State of Alaska
Department of Fish and Game
Sportfish Division

Nomination Form
Fish Distribution Database

04-338

FISH DISTRIBUTION DATABASE CATALOG/ATLAS
CORRECTION FORM

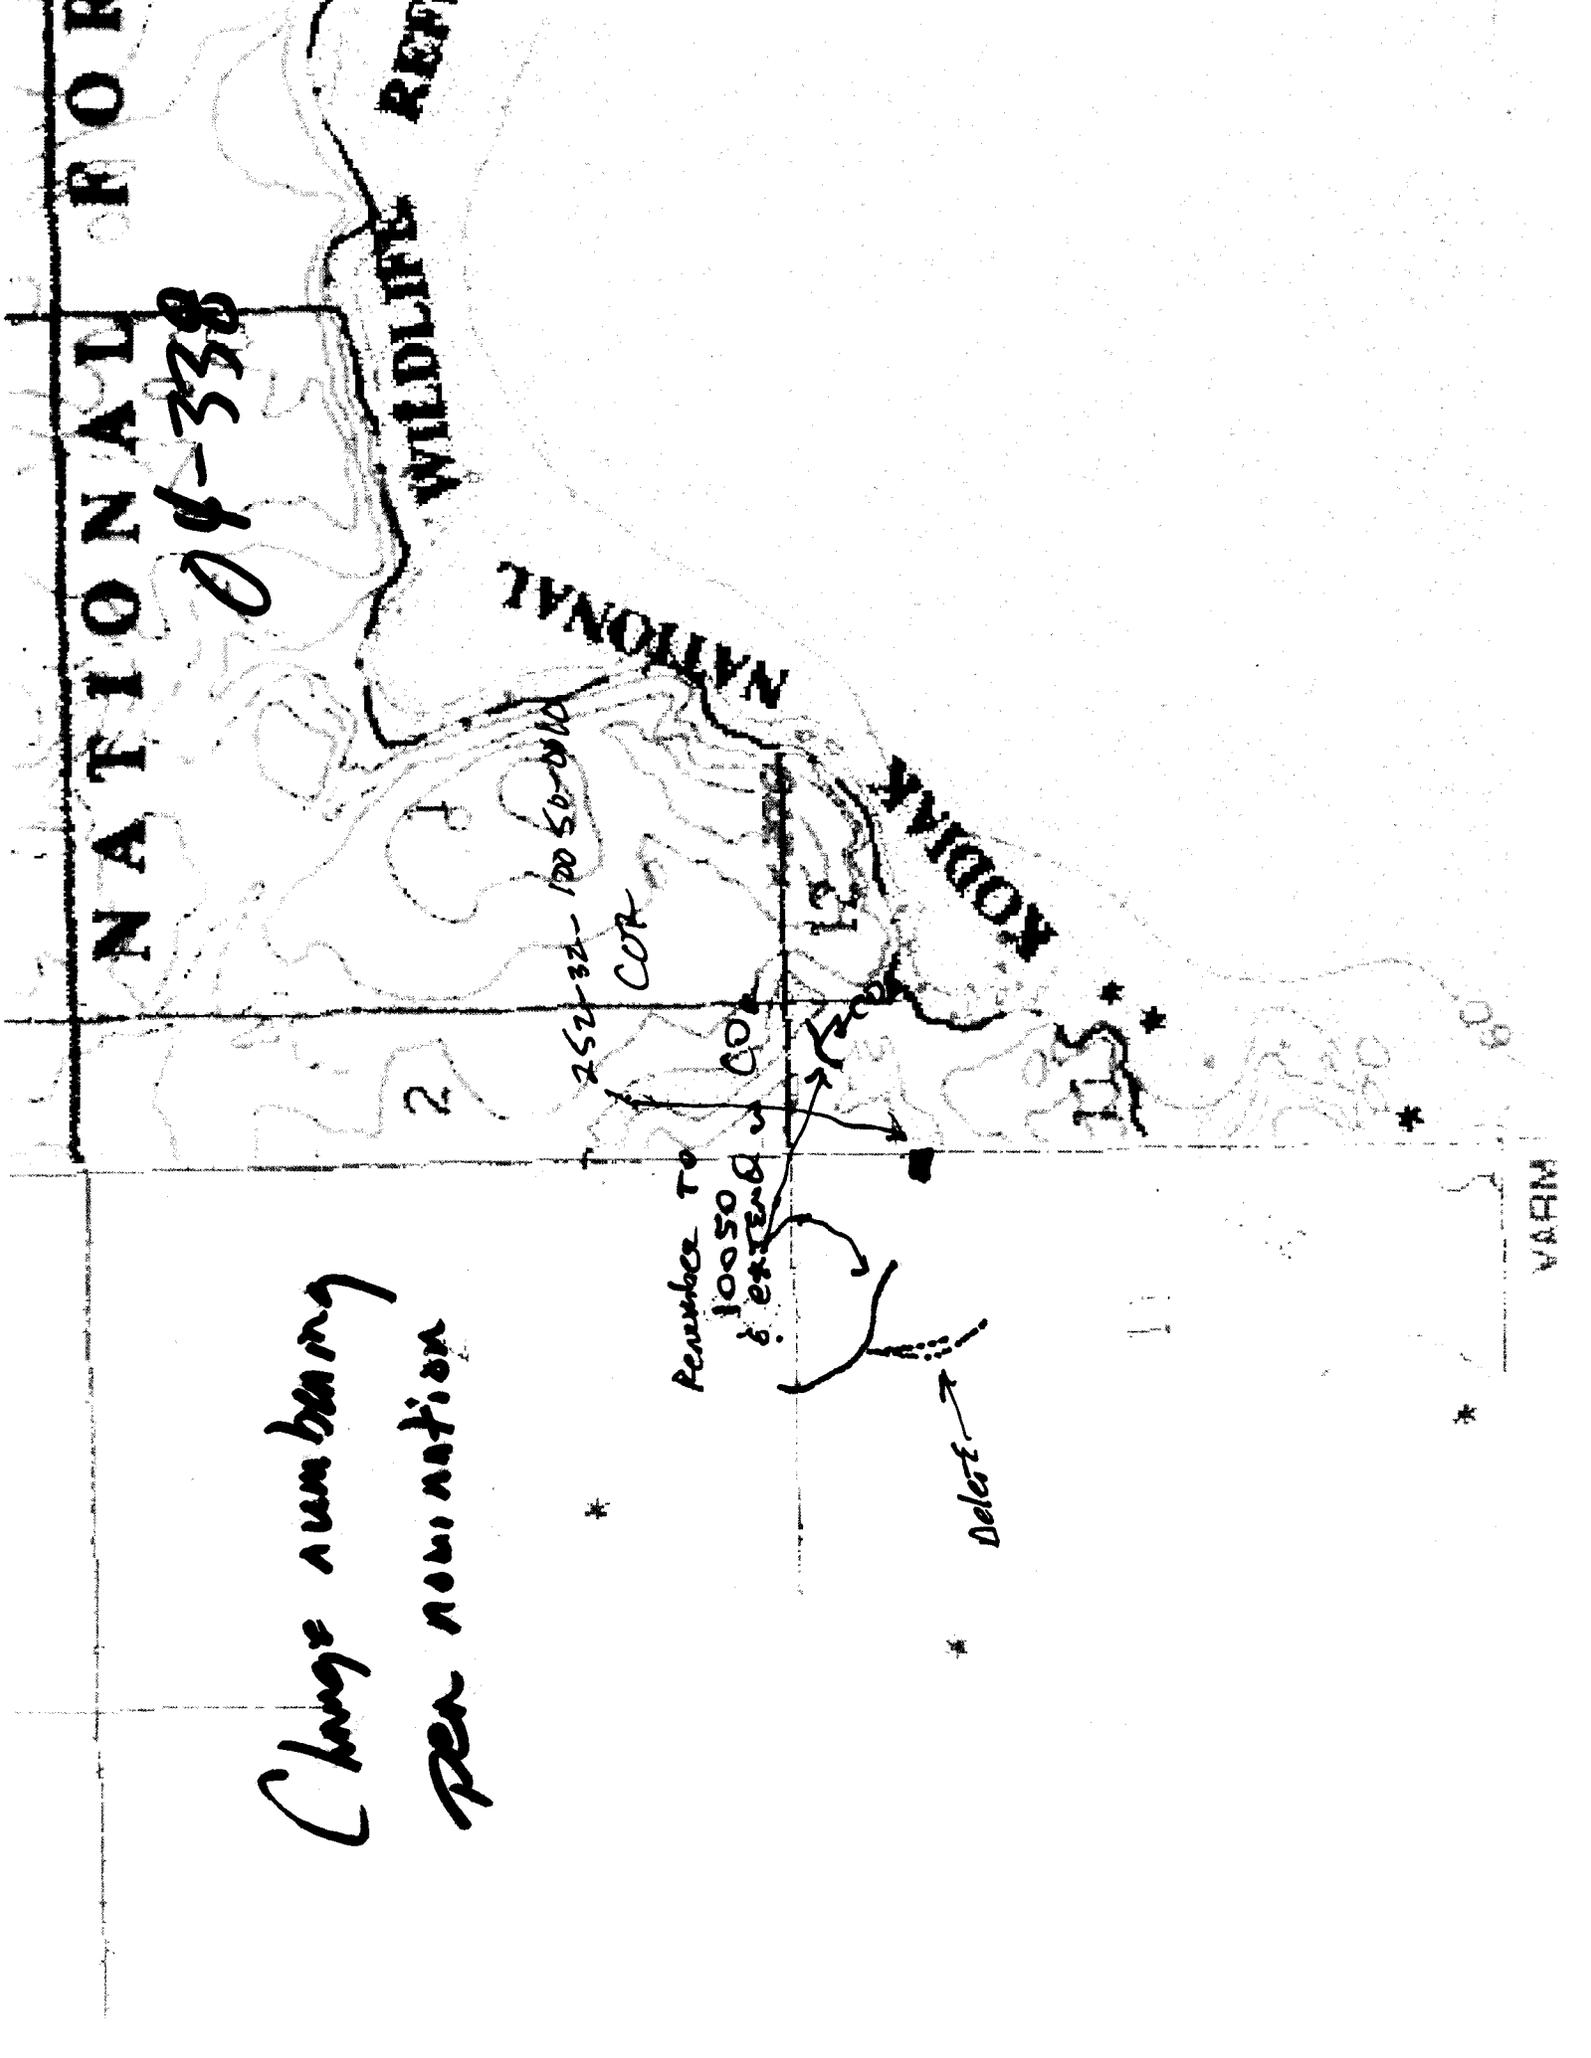
Delete stream 252-32-10050 renumber 10050-2005 as 1st stream
add 1st stream COR 252-32-10050-0010

Comments: These two streams were surveyed and inspected as part of Forest Practices Inspections. Corrections are needed on both streams and one stream needs a slight extension. The upper portion of the main stem stream is currently cataloged as the tributary 252-32-10050-2005 and a minor tributary which likely does not contain anadromous fish is cataloged as the upper end of the mainstem. The streams should be redrawn and renumbered as shown on attached map.

Once this is completed an extension of the main stem above the lake should be done for coho rearing. Rearing coho salmon were trapped in the inlet stream halfway between the two lakes. No barrier exists above this.

The minor tributary currently cataloged as the main stem 252-32-10050 should also be deleted. An excessive gradient just above tidewater, in a small stream with no resting places or jumping pools in all probability prevents fish passage. The stream was trapped, visually searched on one occasion and electroshocked on another without catching anything. The gradient from tidewater is 27% for 50 feet, with a 8% for 45 feet above that. Small cascades and drops exist in this stretch.

Change numbering
per nomination

252-32-10050-010
COR

Remember to
10050
& extend
COR

Delete →

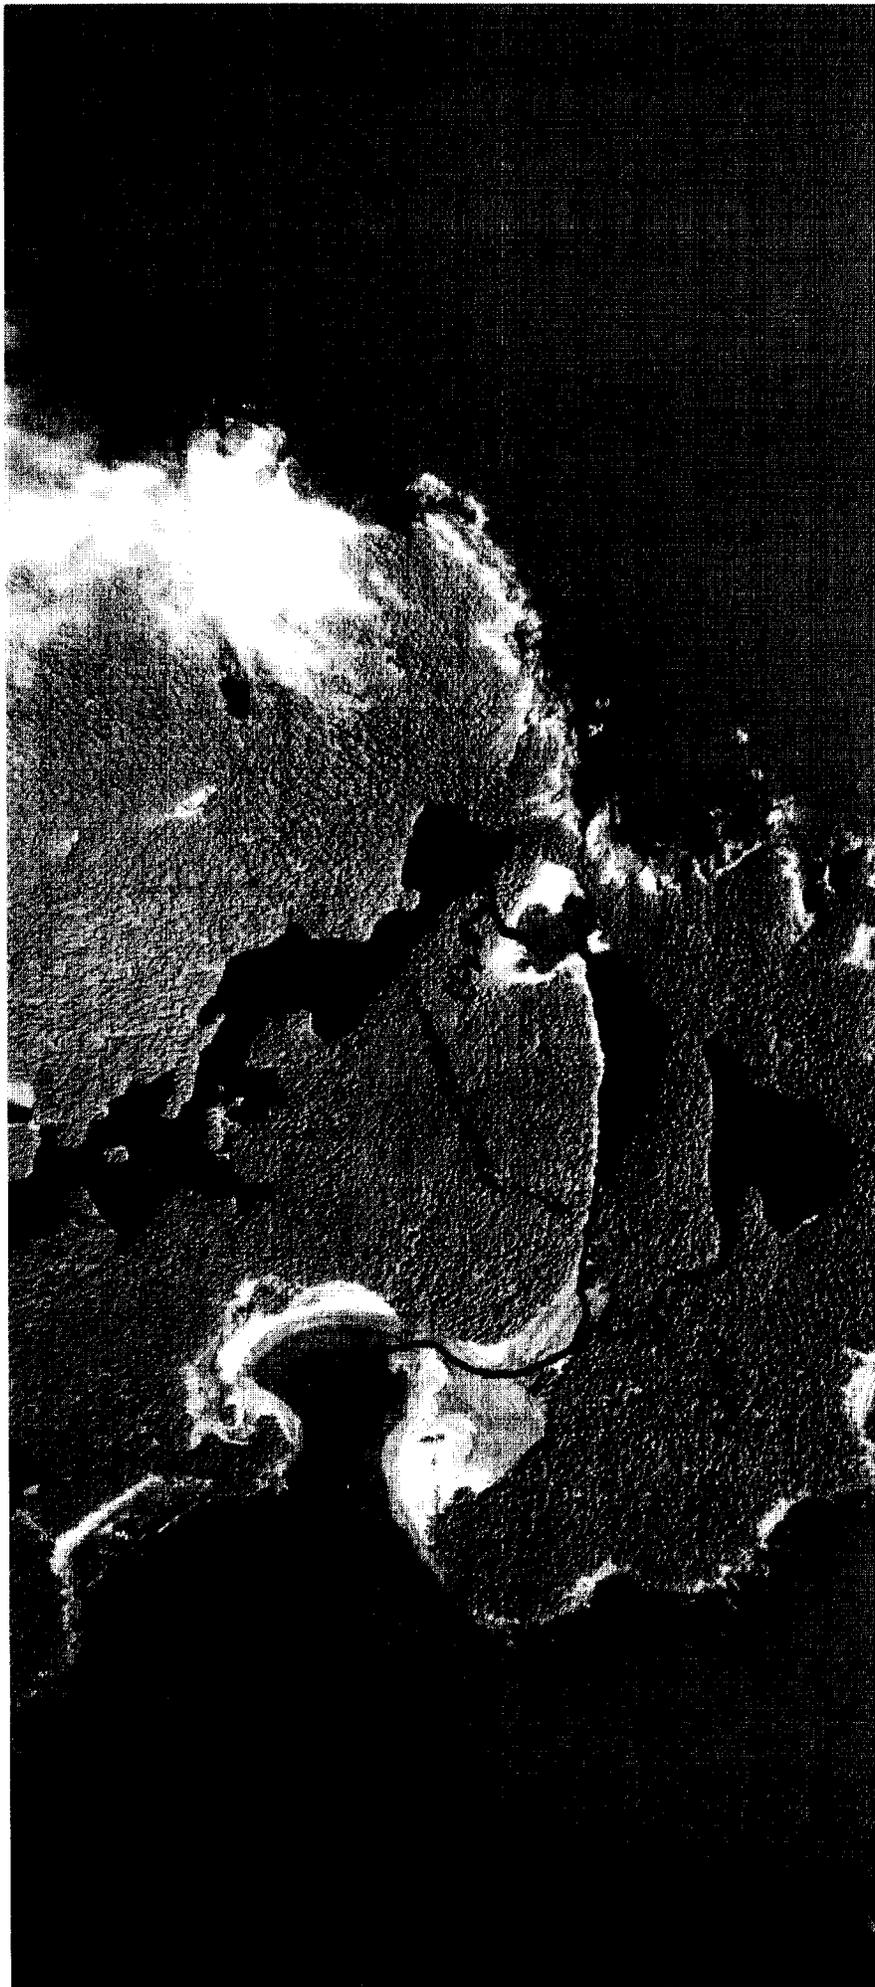
DESCRIBE CHANGE(S): Lake # incorrect on map

appears to be CK in DB (check this)

Add segment above lake on A-2
